July 9, 2019

Ref. T0884

Re: Cate Street Extension Roadway Design Peer Review #3

CATE STREET REVERSE CURVE DESIGN OPTION

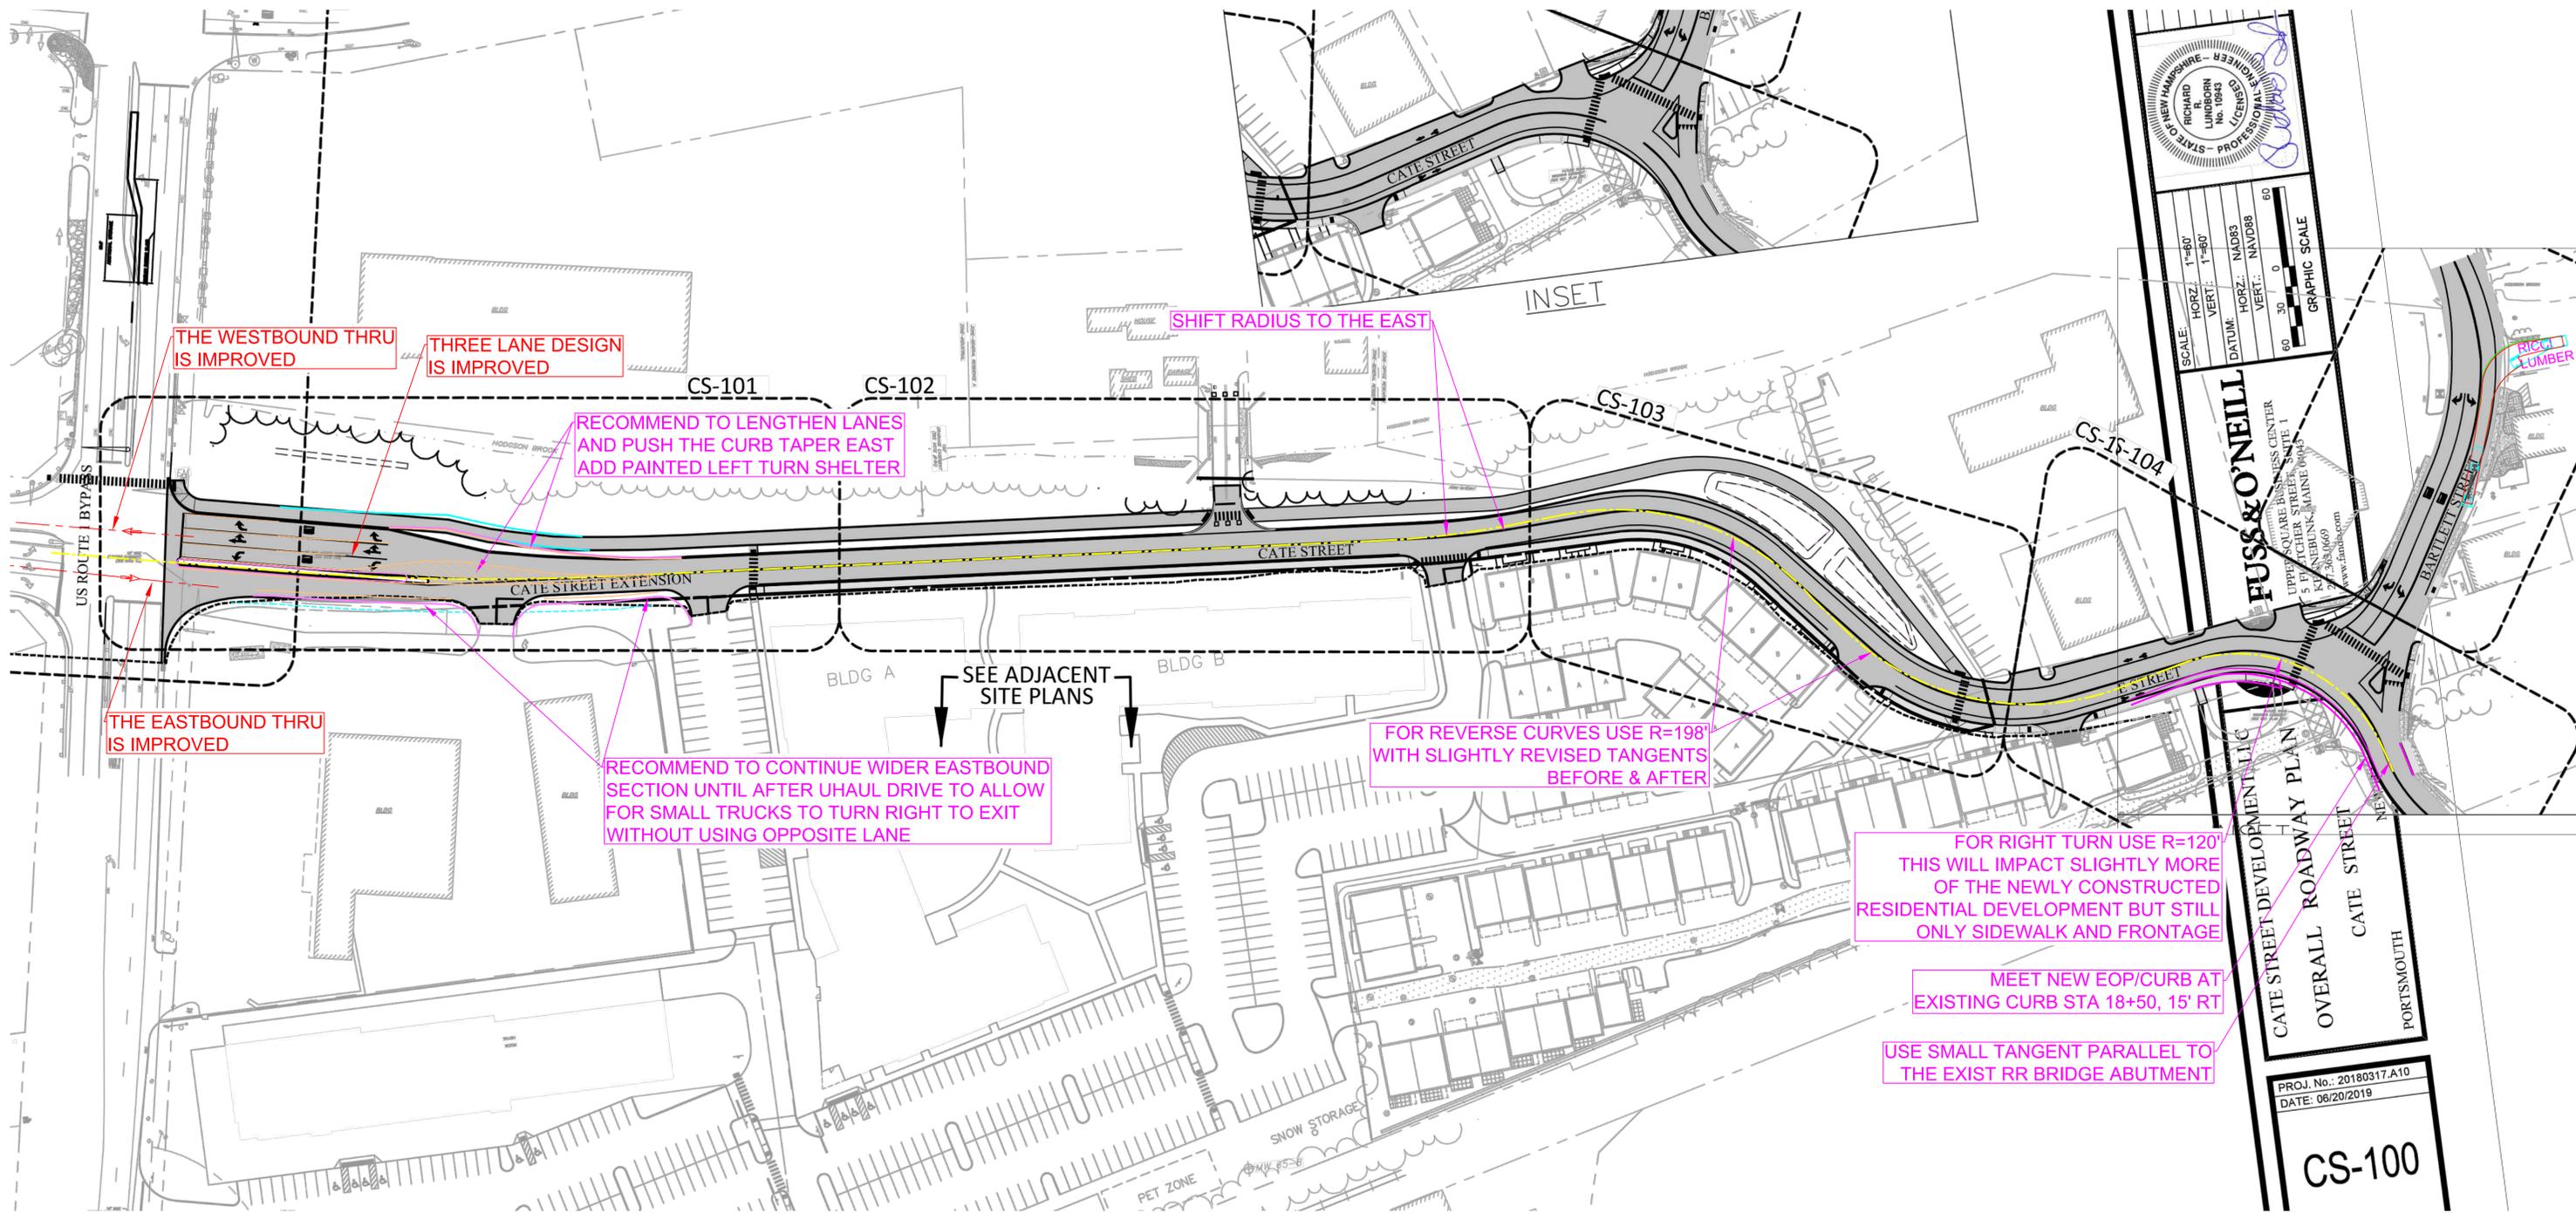
- a. Reverse curves on Cate Street have proposed radii of $R=155'$. We concur that the pinch point at Station 15+00 makes it difficult to flatten the curve without significant impact to the proposed residential town house units. The Applicant should consider adjusting the roadway alignment and adjacent site design to provide a wider roadway with 5' shoulders and use horizontal curves of $R=198'$ to meet a 25 mph design speed, as suggested in the initial peer review letter dated May 13, 2019. It appears that the tangents before and after the reverse curves may be adjusted to create an alignment consistent with a 25 mph design speed (see attached sketch).

- b. The right turn from Cate Street to Bartlett Street ($R=110'$) is very tight for this free flow movement. We concur that the existing railroad bridge is a design constraint that currently limits the size of trucks from this approach due to the vertical clearance; however, the bridge is proposed to be replaced in the future. In the latest design revision, the southern curb line does not meet the existing and appears to narrow the roadway through the bridge area. We recommended flattening the centerline radius as much as possible (a radius of $R=120'$ appears to be feasible with adjusted tangents) and match into the existing granite curb on both sides just prior

to the bridge abutment at approximate Station 18+35. Consider using a short tangent parallel to the edge of the railroad bridge abutment instead of the reverse curve as shown. This option appears to accommodate 11' lanes and 4' shoulder on the west side. A minor amount of additional widening and sidewalk reconstruction may be necessary within the newly constructed residential development.
